ADDENDUM NO. 1

RFP EVMS GROSSLAB19-101

Gross Anatomy Lab Improvements at Lewis Hall

Date: May 07, 2019

E202

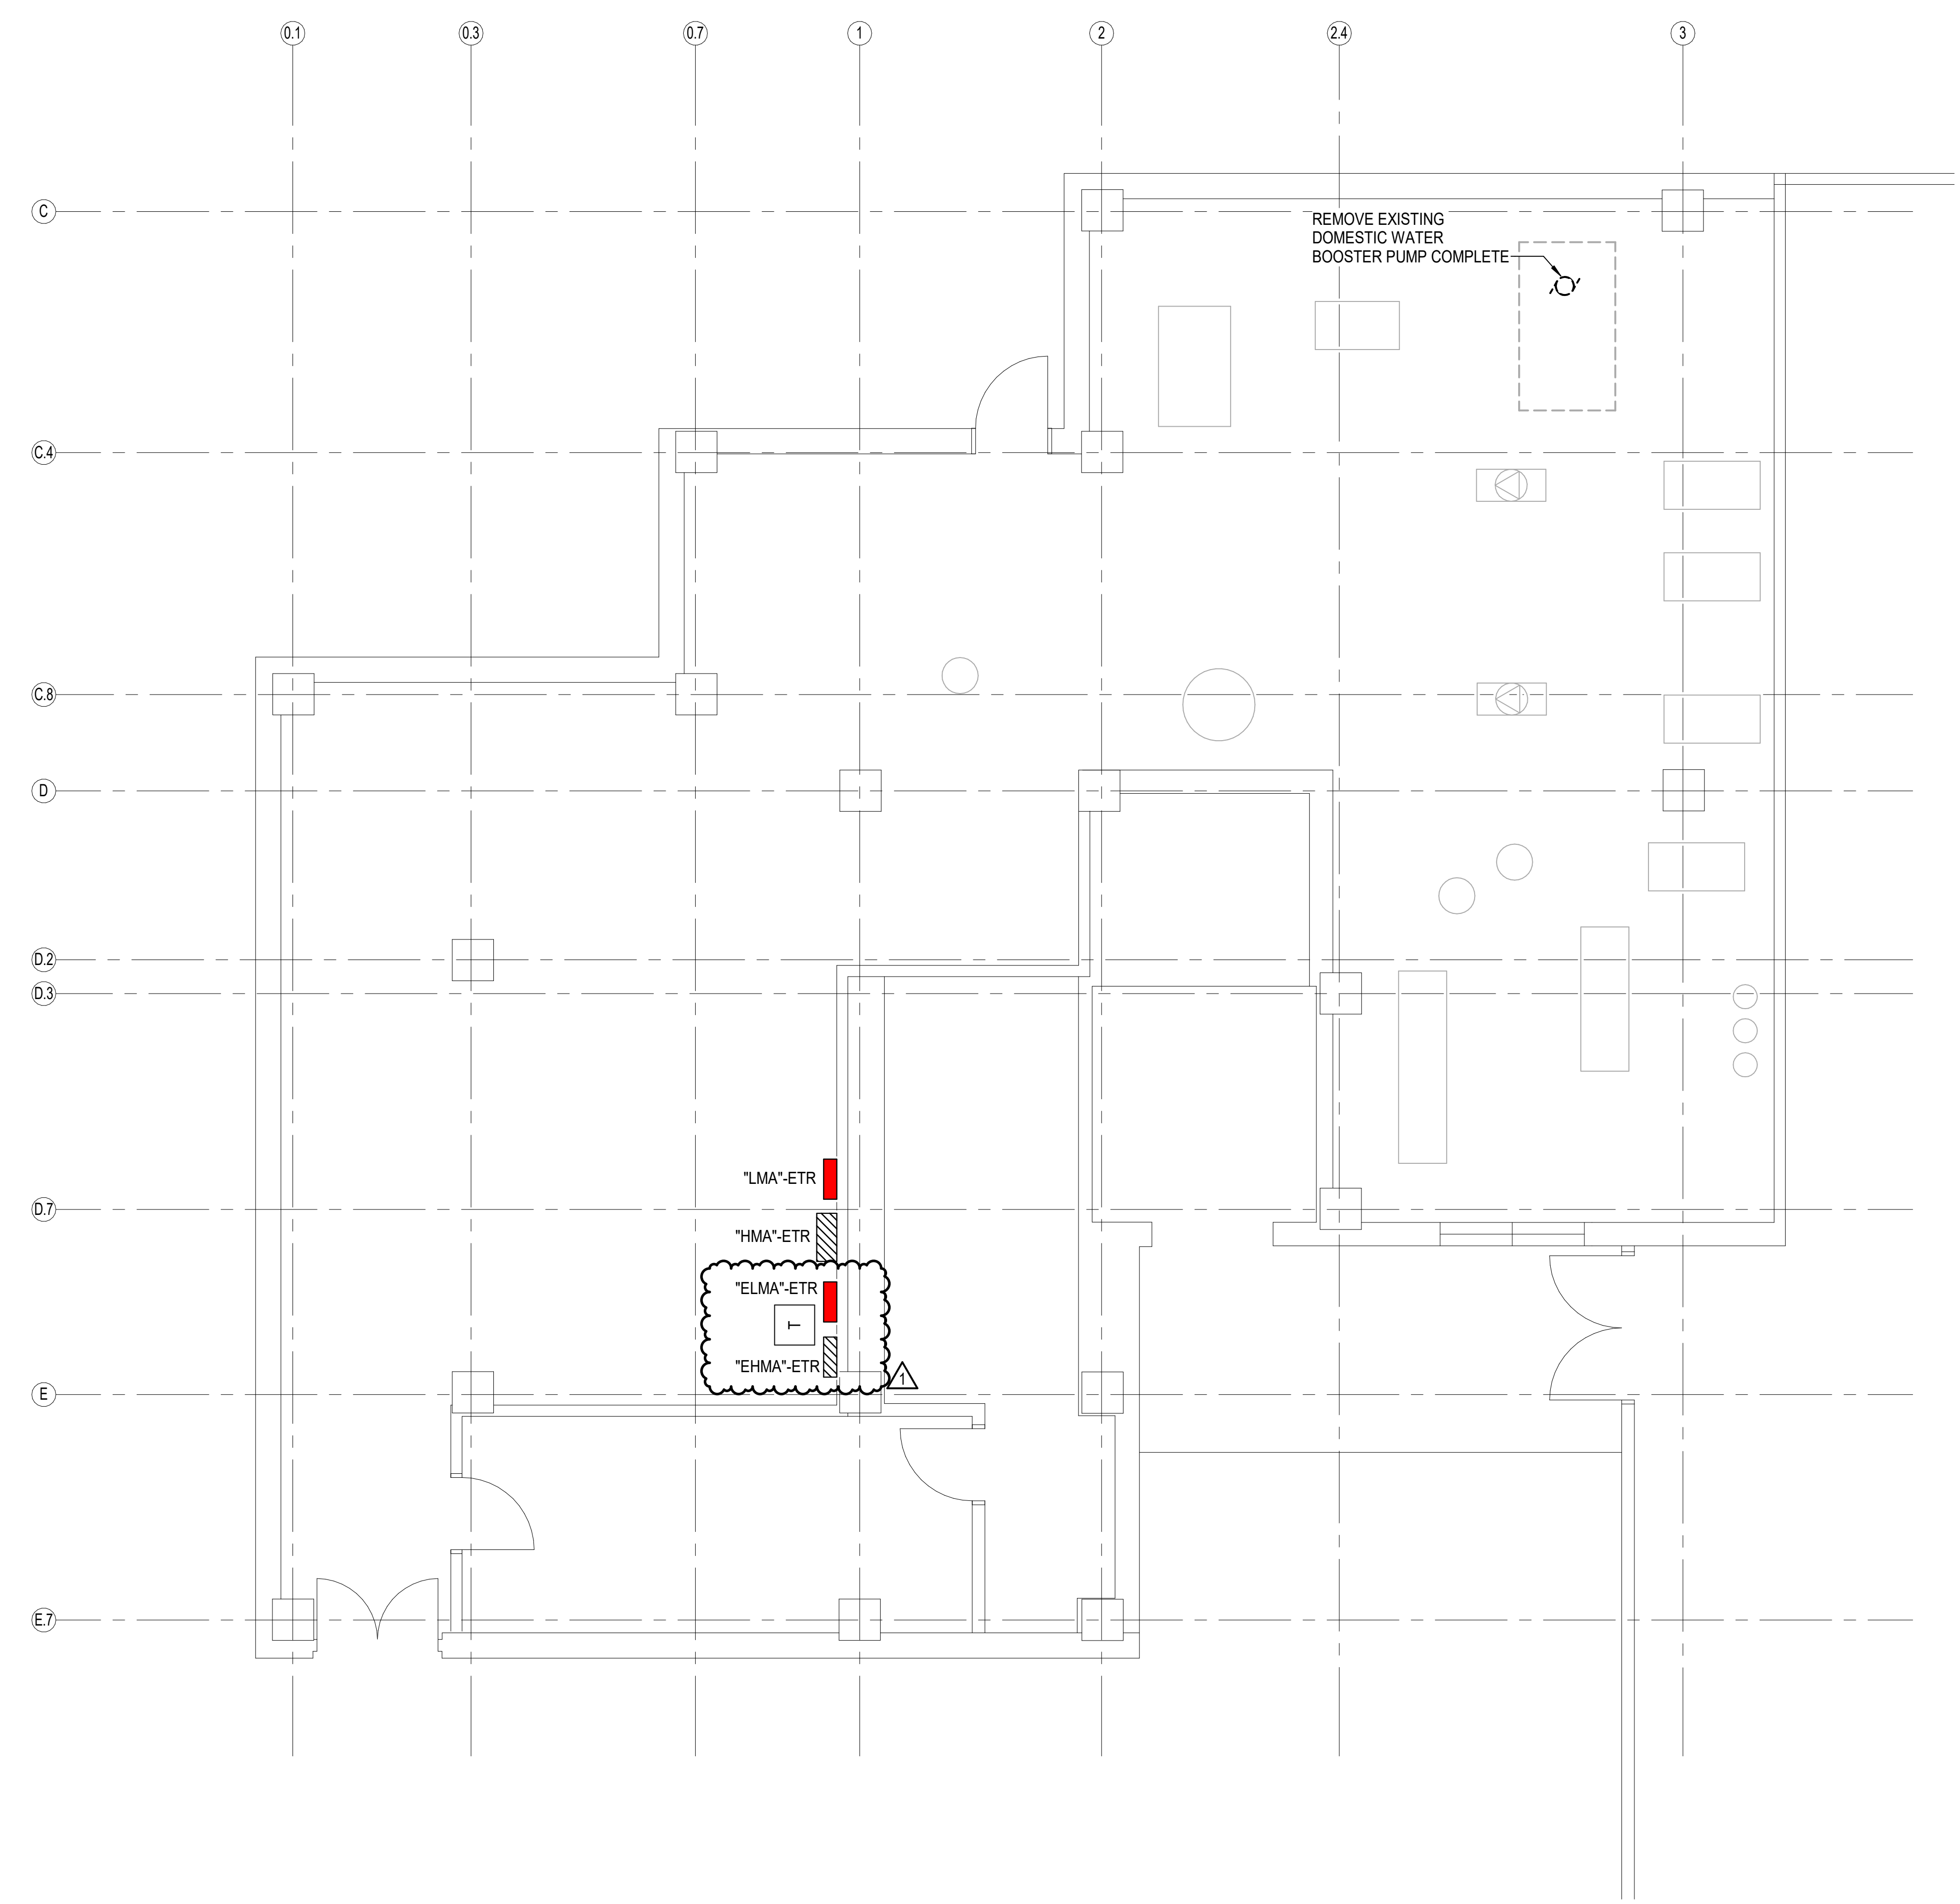
Drawing E202: See attached revised sheet.

ED202

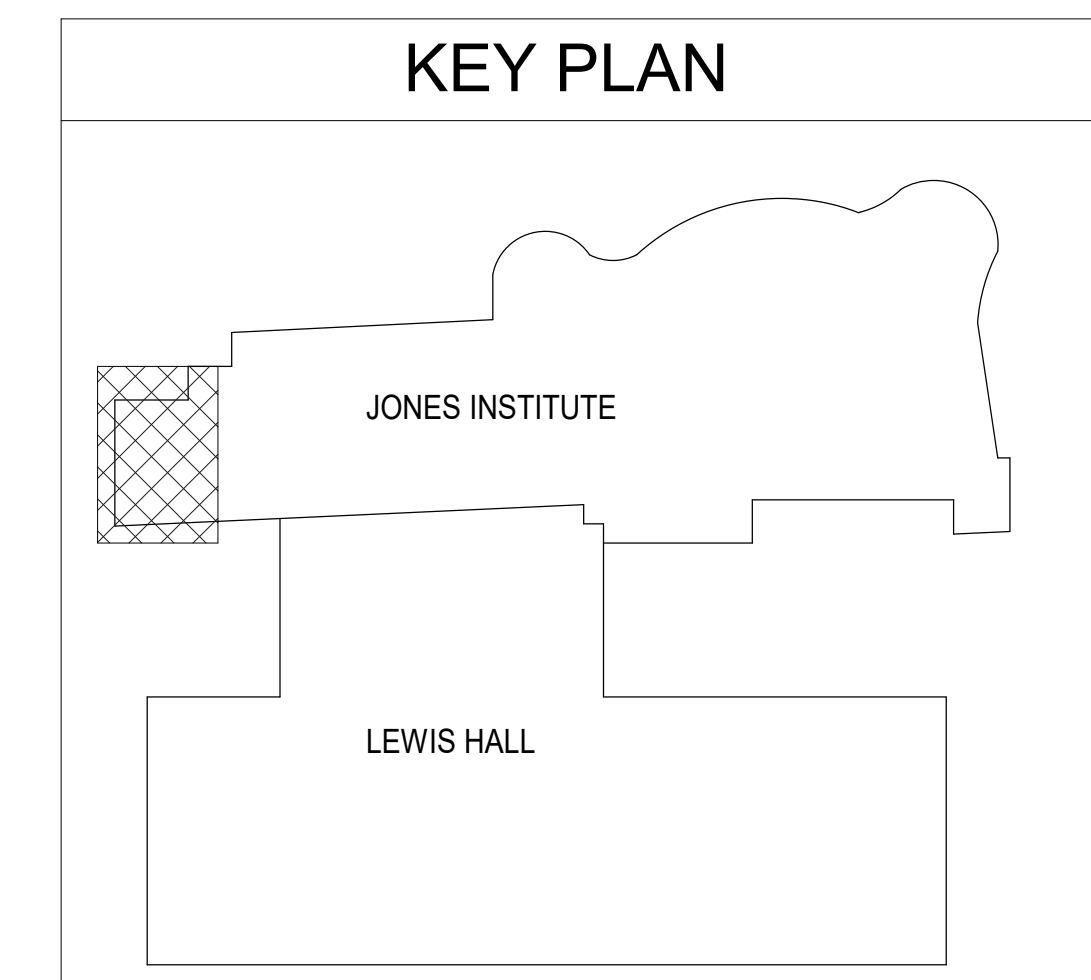
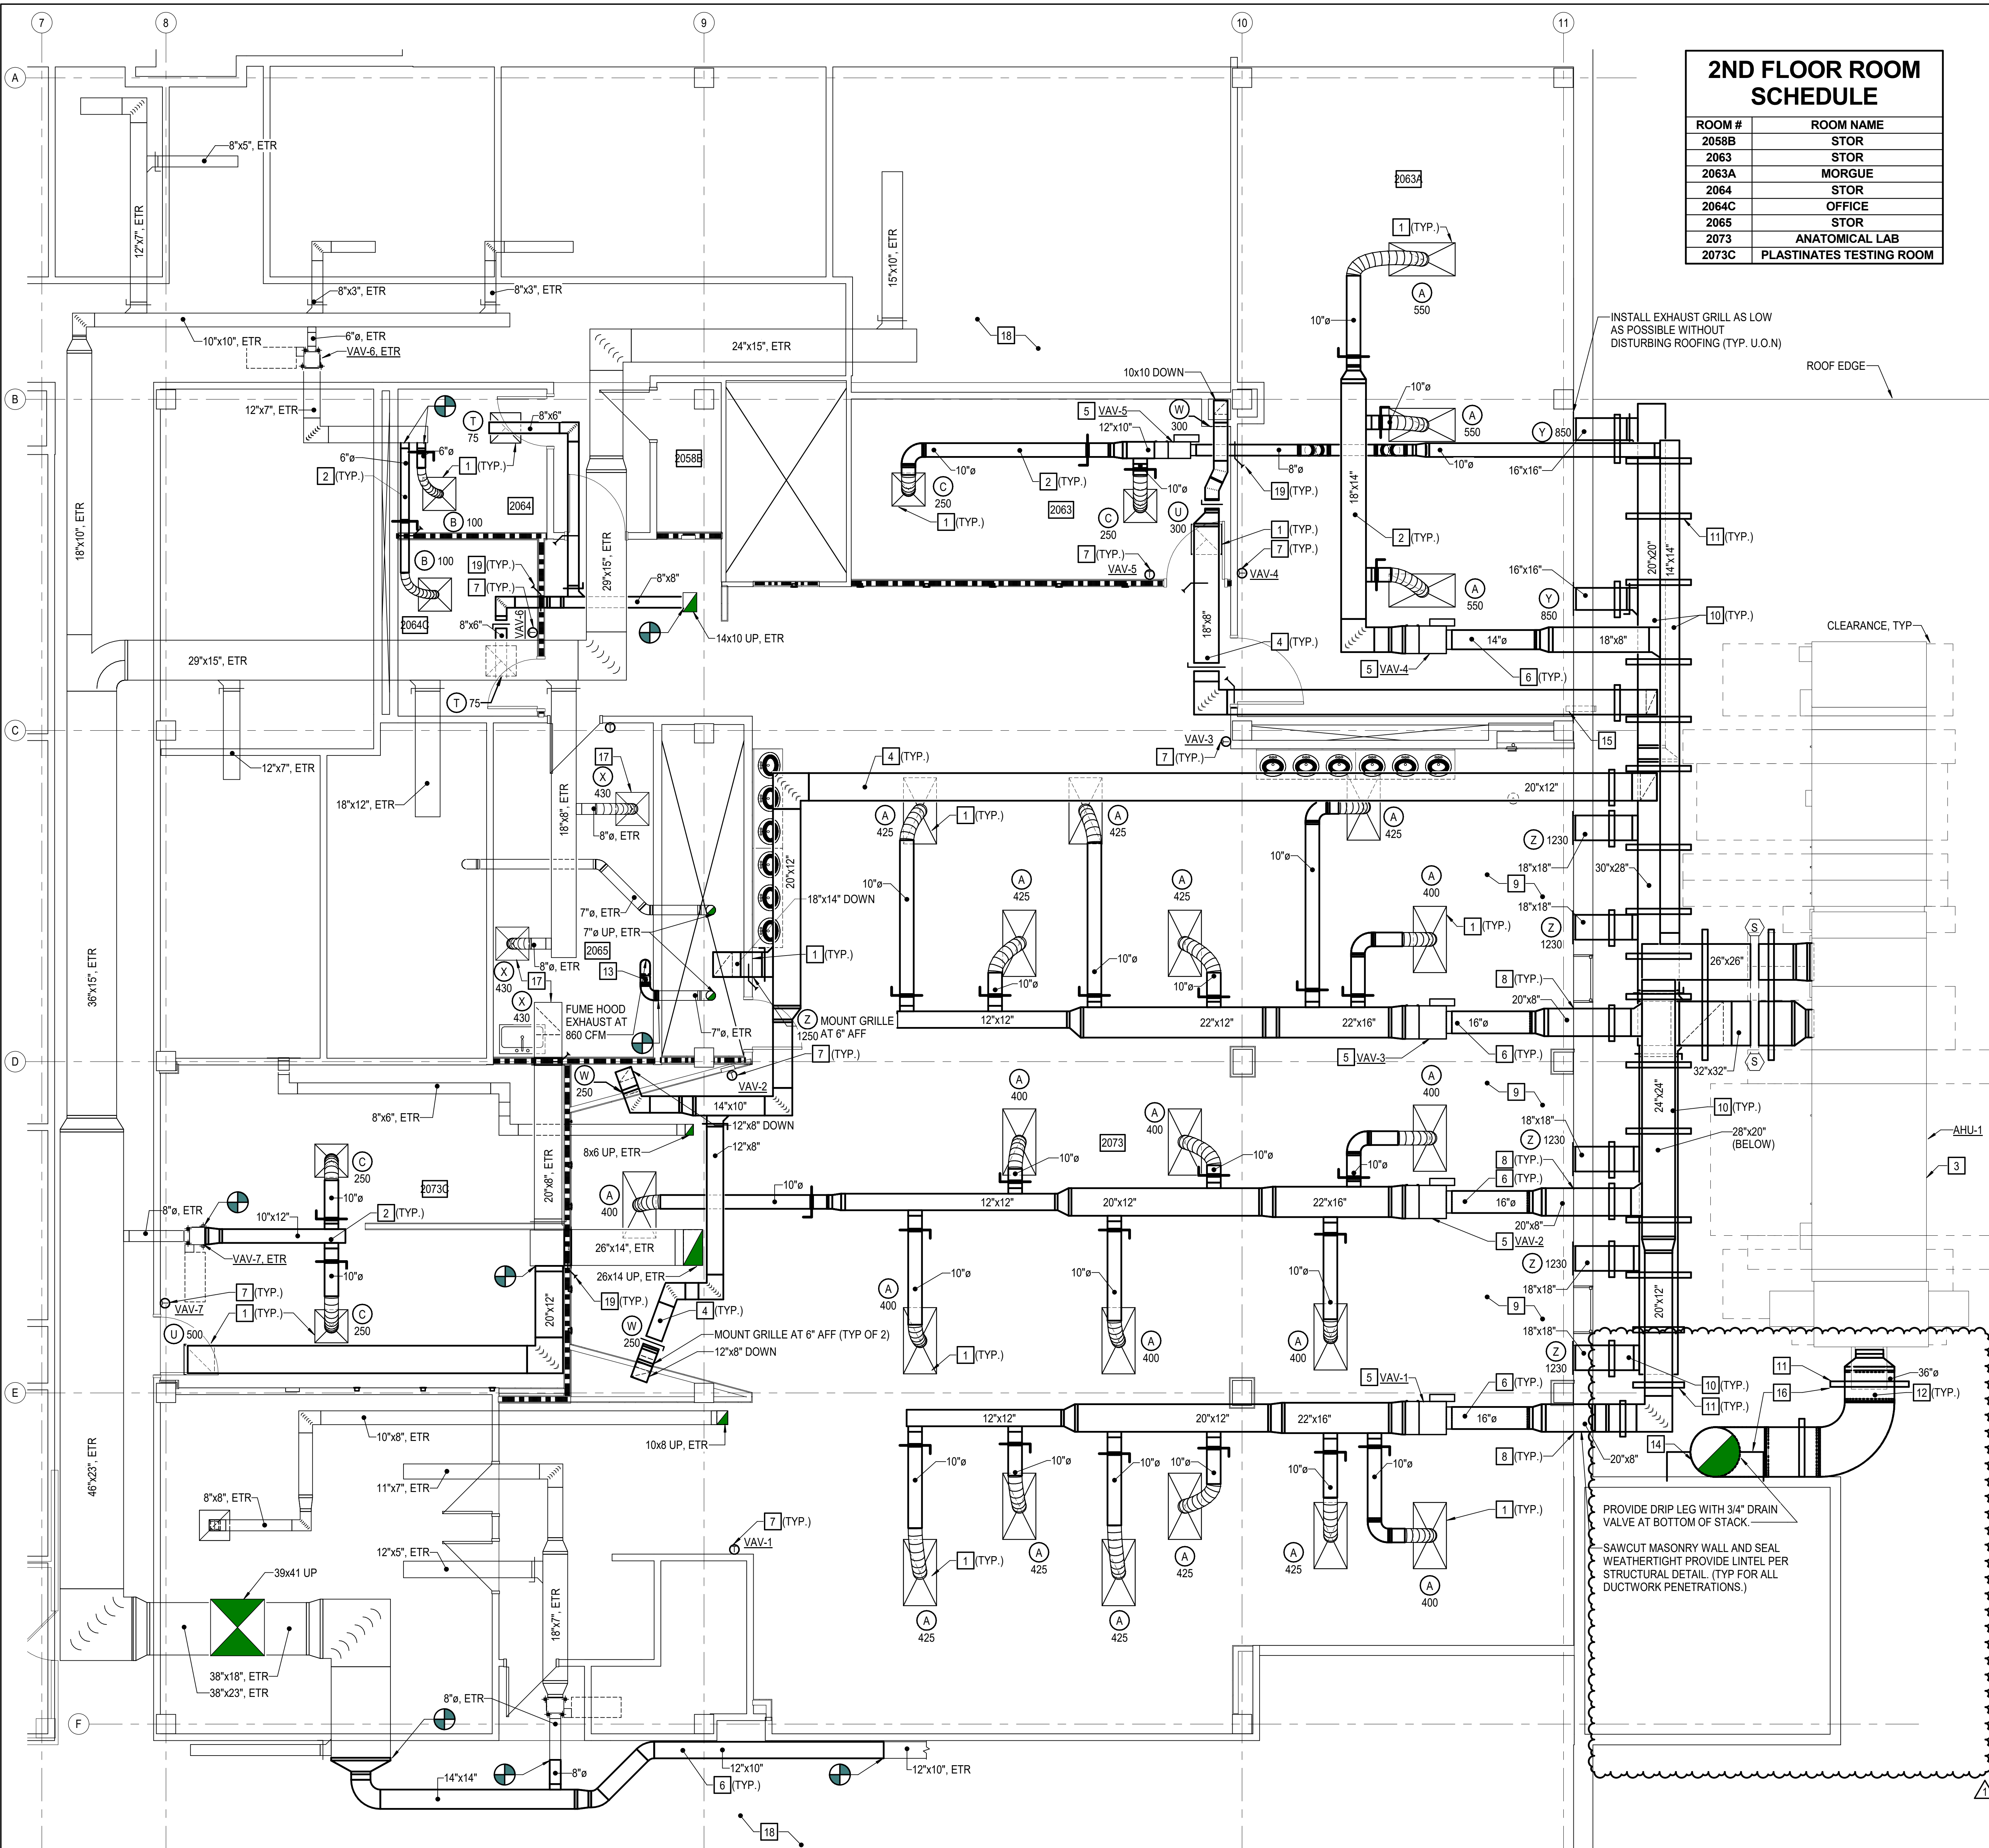
Drawing ED202: See attached revised sheet.
